# UNITED STATES PATENT AND TRADEMARK OFFICE

APPLICATION NO.	FILING DATE	FIRST NAMED INVENTOR	ATTORNEY DOCKET NO.	CONFIRMATION NO.
10/532,277	04/21/2005	Andrea Drollinger	14150	8515

## Office Action Summary

## DETAILED ACTION

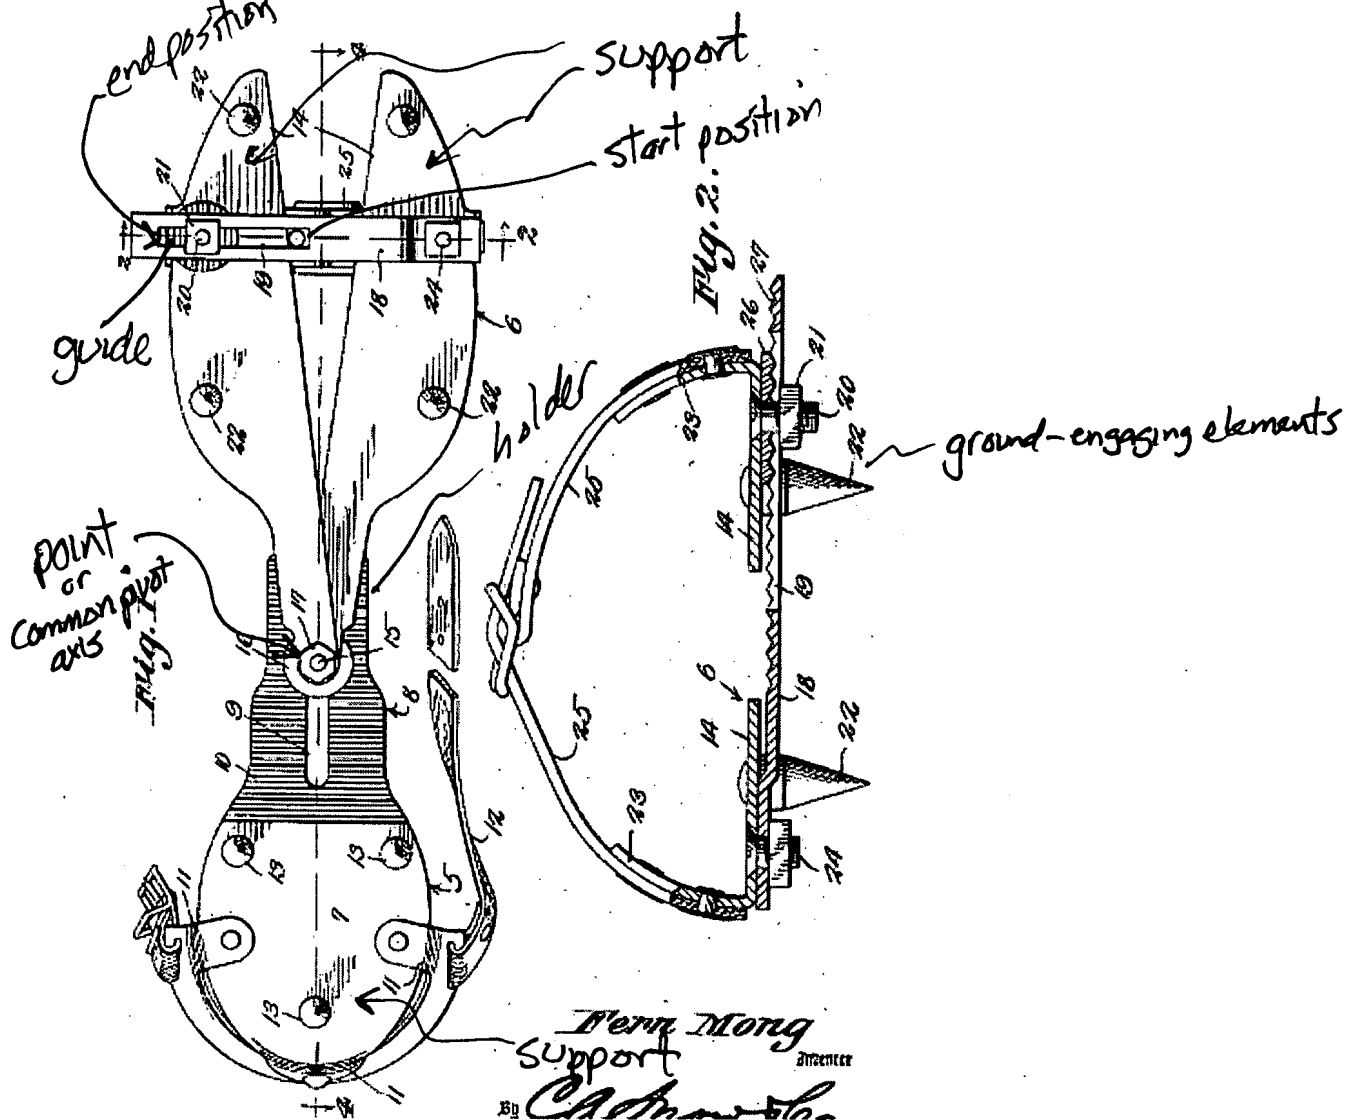
Mong teaches an ice creeper (sole with downwardly projecting ground elements) which is detachably mounted on a shoe, wherein the ice creeper has two support plates with ground-engaging elements which are guided and held to move forward and backward along an arc; see the marked-up figure below. The shoe can inherently be used for sports.

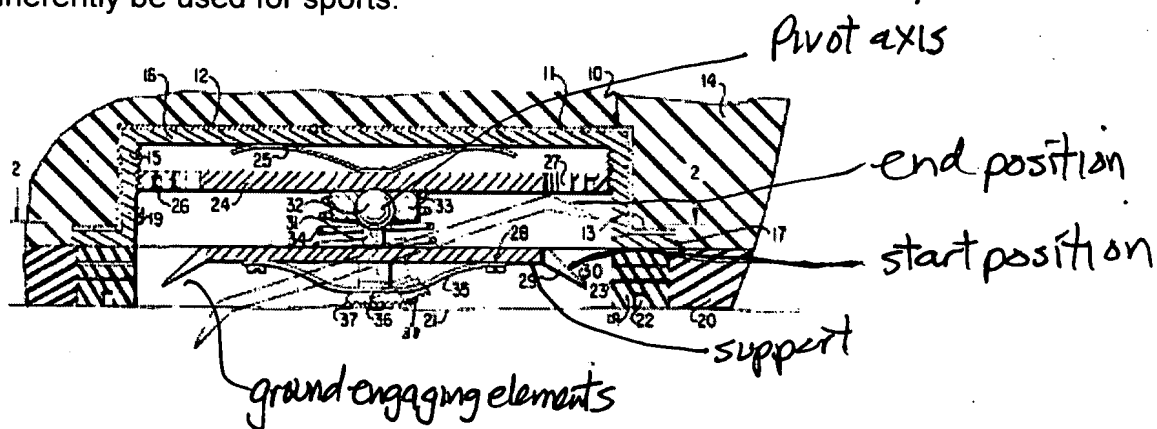
Rice teaches an antislip footpiece for a shoe having structure as claimed. See the marked-up figure below. The support (plate 28) with downwardly projecting ground-engaging elements (29) are guided and held to move forward and backward along an arc; figure 1 shows in dashed lines the plate moving about the arc. The shoe can inherently be used for sports.
